In the Matter of: Entergy Nuclear Operations, Inc.  
(Indian Point Nuclear Generating Units 2 and 3)

NL-13-122

SUBJECT: Reply to Request for Additional Information Regarding  
the License Renewal Application  
Indian Point Nuclear Generating Unit Nos. 2 & 3  
Docket Nos. 50-247 and 50-286  
License Nos. DPR-26 and DPR-64

REQUEST FOR ADDITIONAL INFORMATION, SET 2013-04  
RELATED TO INDIAN POINT NUCLEAR GENERATING UNIT NOS. 2 AND 3  
LICENSE RENEWAL APPLICATION

**Figure 1 Lower Radial Support System Engagement**

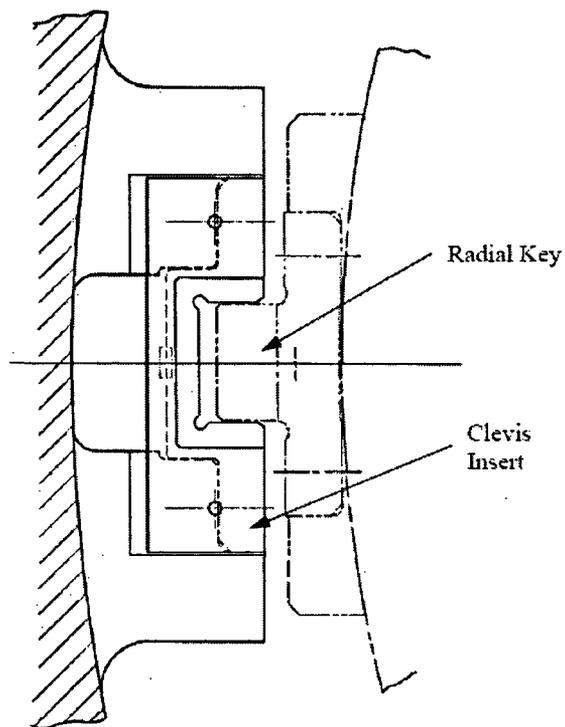
Appendix A to MRP-227-A indicates that failures of Alloy X-750 clevis insert bolts were reported by one Westinghouse-designed plant in 2010. A recent metallurgical analysis of bolts removed from this plant confirmed that the bolts cracked due to primary water stress corrosion cracking (PWSCC). Appendix A to MRP-227-A indicates that most of the failures of Alloy X-750 material have occurred in material with heat treatment condition AH1, while Alloy X-750 given the high temperature heat treatment (HTH) has proved more resistant to PWSCC.

The only aging mechanism requiring management by MRP-227-A for the clevis insert bolts is wear. The clevis insert bolts are categorized as an "Existing Programs" component under MRP-227-A, with the ASME Code, Section XI Inservice Inspection program credited for managing aging due to wear only. The ASME Code, Section XI specifies a VT-3 visual inspection for the clevis insert bolts which may not be adequate to detect cracking before it results in bolt failure.

The staff requests that Entergy modify the MRP-227-A inspection requirement for the clevis insert bolts as necessary to manage the effects of PWSCC for the IP2 and IP3 bolts. If the inspection requirement is not modified, the staff requests that Entergy provide a technical justification for the adequacy of the existing inspection requirement to manage PWSCC.

The main function of the lower radial support system (LRSS) is to prevent tangential or rotational motion of the lower internals assembly while permitting axial displacement and differential radial expansion. Indian Point Units 2 and 3 have six radial supports spaced at 60 degree intervals around the circumference of the vessel (see Reference [5], Figure 1). Because of the small tangential clearance between the radial keys and the clevis insert, the keys are potentially subjected to flow-induced vibration loads and wear at the key-to-keyway (clevis) interface. These supports are designed to prevent excessive tangential displacement of the lower internals during seismic and loss of coolant accident (LOCA) conditions. The supports also limit displacements and misalignments in order to avoid overstressing the core barrel and to ensure that the control rods can be freely inserted. Therefore, providing the clevis inserts remain in place, the design function of the LRSS will be maintained during seismic and LOCA conditions.

Crack detection prior to bolt failure is not required due to inherent design redundancy. The ability of the LRSS to perform its intended design function under seismic and LOCA condition loadings is unrelated to the integrity of the cap screws and pins that are used to hold the clevis insert in place. The cap screws and the dowel pins hold the clevis inserts in place so as to minimize long term vibration and wear of the mating parts.

Should cap screws fail during operation, it could result in potential increased wear of mating surfaces. Any increased wear, which would occur over several operating cycles, will not impact the function of the reactor internals components. This is based on operating experience with

damaged bolts and one dowel pin as described in the InfoGram [5] which showed no discernible change in the clevis insert wear surfaces after operation for two additional cycles.

Complete disengagement of one of the clevis inserts is highly unlikely based on the available gaps with surrounding components (see Figure 1). Even if it were postulated that one of the clevis inserts becomes non-functional, the other lower radial supports are capable of resisting all of the internal and external asymmetric loads. Wear or some degradation of a key might occur, but the key would still be expected to maintain functionality. Taken as a whole, the core barrel and LRSS system are expected to maintain their design function with degraded clevis insert bolts. Based on the evaluations performed to date, there are no safety or operability concerns with clevis insert bolt failure.

As described in the InfoGram [5], Westinghouse performed evaluations of the potential for loose parts with failed clevis insert bolts for the plant referenced in this RAI. The loose parts evaluation concluded that the separated cap screw heads will remain captured in the clevis insert counterbores and will not impact operation. However, lock bars at the degraded cap screw locations have experienced wear-related degradation; therefore, the potential for loose parts from the lock bars to affect other locations in the reactor vessel was also evaluated. Westinghouse concluded that no significant degradation of mechanical components is expected as a result of potential loose parts from the lock bars in the primary system.

The MRP-227-A categorization for wear only is based on the primary concern for clevis insert looseness and wear of the clevis insert and radial key interfacing surfaces that could potentially lead to increased motion at the bottom end of the core barrel, rather than bolt material cracking. The video camera visual inspections at a ten-year interval by qualified personnel that are specified in the ASME Code Section XI and MRP-227-A are capable of identifying wear or dislodged components of the clevis insert cap screws or dowel pins at any location, if they exist.

The susceptibility of Alloy X-750 to PWSCC and low-temperature crack propagation may have been a contributor to the observed degradation detected in 2010; however, at this time, this has not been confirmed by metallurgical analysis. It was also indicated by the Staff that most failures of Alloy X-750 material have occurred in material with heat treatment condition AH. The Alloy X-750 material used at Indian Point Units 2 and 3 for clevis insert bolts is not heat treatment condition AH.
